TECHNICAL BULLETIN
Bell Helicopter **TEXTRON**

No. 212-06-203

SUBJECT: INSTALLATION OF MISSING RIGGING RIVETS

HELICOPTERS AFFECTED: Spare Tailbooms P/N 212-030-100-203 or -229, serial number PZ-1001 through PZ-1053.

Figure 1
Rigging Rivet Installation

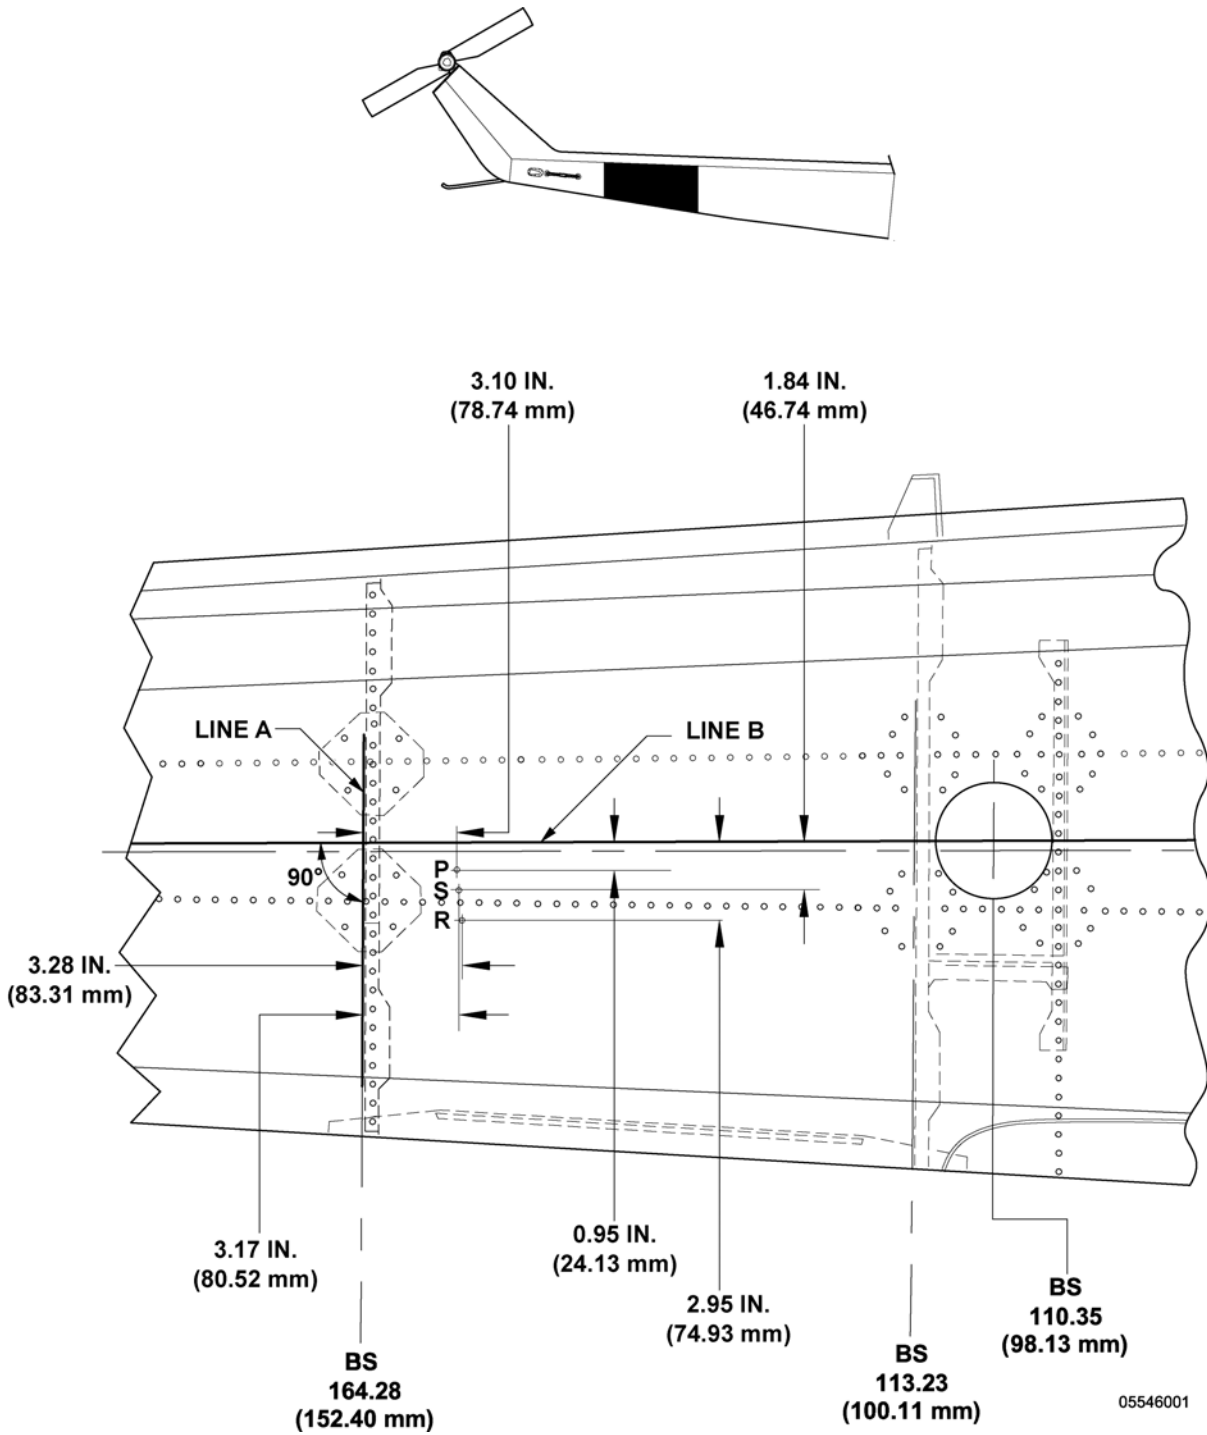
It was recently brought to Bell Helicopter's attention that some tailbooms were missing three reference rivets used to rig the elevators. Although these rivets have no use on Model 412 & 412EP, they are necessary when the affected tailbooms are installed on Model 210 or 212 helicopters. This Technical Bulletin shows how and where to install these rivets. Only serial numbers with prefix PZ are affected.

1. Make helicopter ready for maintenance.
2. Remove both lower access doors on tailboom belly. Remove RH elevator.
3. Locate position for rivets as follows (refer to Figure 1):

- a. From inside of tailboom structure, measure distance between center of rivets and bulkhead at BS 164.28. Transfer dimension on outside of tailboom structure and add 0.040" for bulkhead thickness. Repeat at two other locations to allow the tracing of a vertical line (Line A) at station 164.28 (aft face of bulkhead).

- b. Using a construction square, mark a line (Line B) perpendicular to station 164.28 and passing through the center of elevator horn hole at station 110.35.

- c. Locate holes for rivets as shown on Figure 1. Drill and deburr holes (#27 size) for all 3 rivets, as shown on Figure 1. Hole for rivet "S" may interfere with nearby stringer. If such interference exists, remove enough rivets to insert a small protective sheet of CRES between stringer and skin. Using a 1/4" diameter router bit, remove minimum amount of metal from stringer to clear rivet tail. Deburr, remove protective sheet and reinstall rivets attaching stringer.

4. Install rivets "P", "R" and "S" (P/N NAS9304B-4-01), as shown on Figure 1. Apply primer to rivet tails and stringer. Touch up exterior paint.
5. Reinstall RH elevator and close access door.
